GRAND GULF NUCLEAR STATION, UNIT 1

AMENDMENT TO FACILITY OPERATING LICENSE

Amendment No. 99
License No. NPF-29

ATTACHMENT TO LICENSE AMENDMENT NO. 99

FIGURE 3.2.1-1 MAPLHGR VS AVERAGE PLANAR EXPOSURE

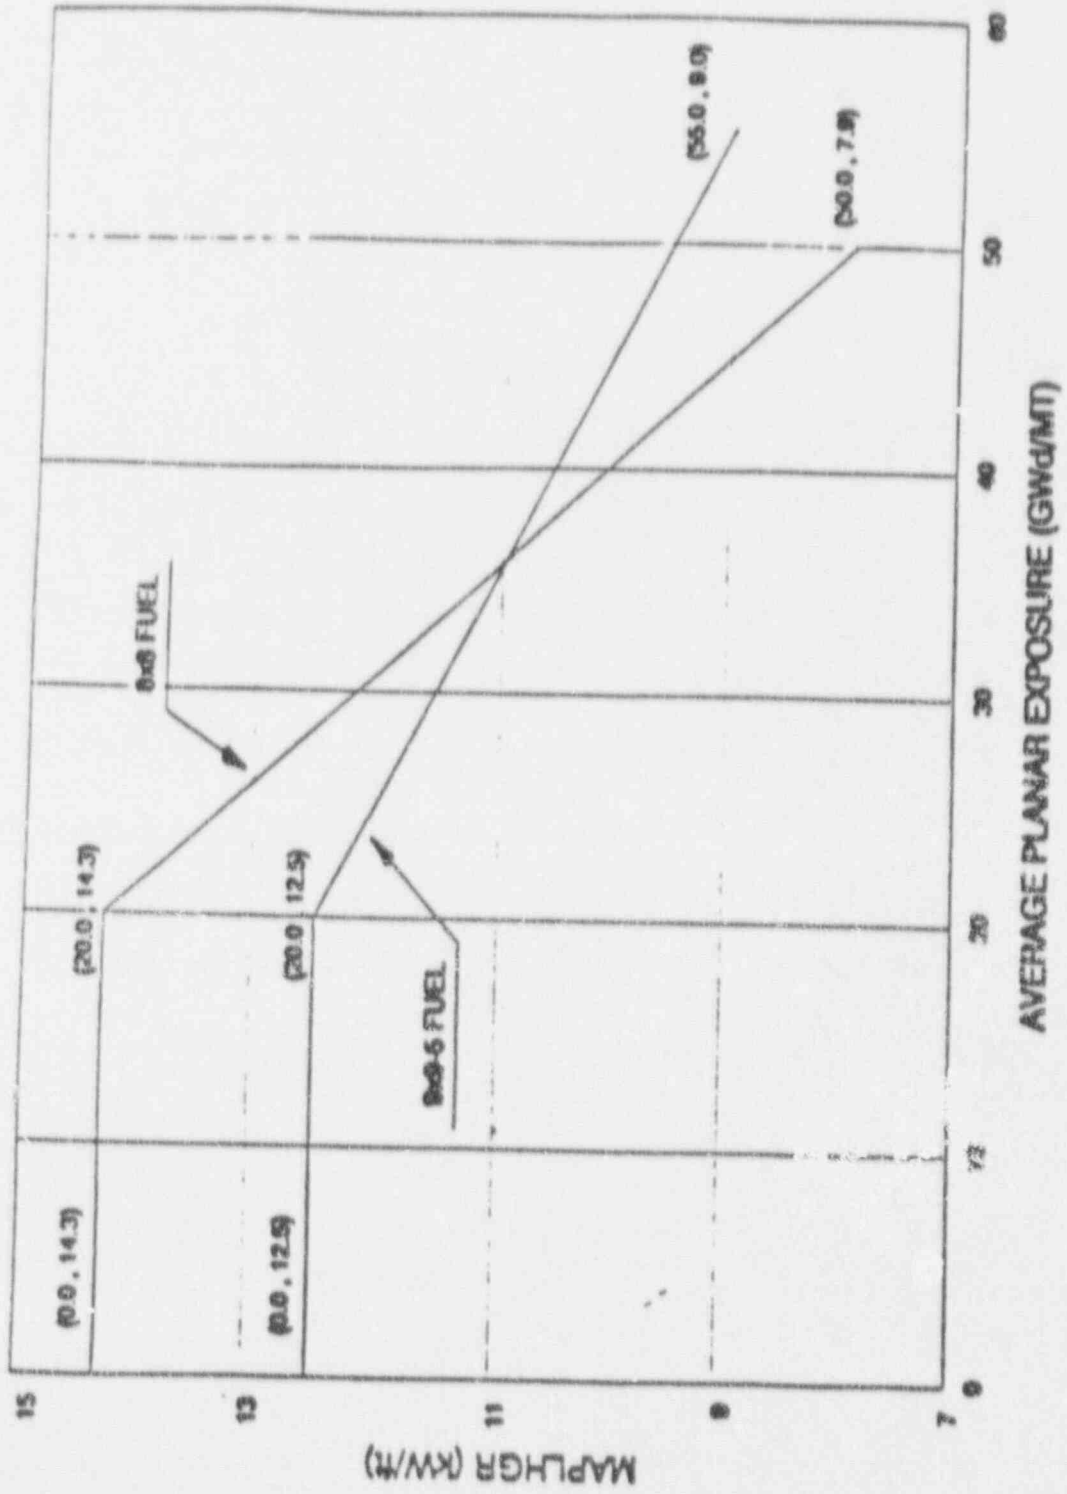
3.2.1 During two loop operation, all AVERAGE PLANAR LINEAR HEAT GENERATION RATES (APLHGRs) for each type of fuel as a function of AVERAGE PLANAR EXPOSURE shall not exceed the limits shown in Figure 3.2.1-1.

During single loop operation, the APLHGR for each type of fuel as a function of AVERAGE PLANAR EXPOSURE shall not exceed the limit shown in Figure 3.2.1-1 multiplied by 0.86.

During two loop operation or single loop operation, with an APLHGR exceeding the limits of Figure 3.2.1-1 as corrected by the appropriate multiplication factor, initiate corrective action within 15 minutes and restore APLHGR to within the required limits within 2 hours or reduce THERMAL POWER to less than 25% of RATED THERMAL POWER within the next 4 hours.
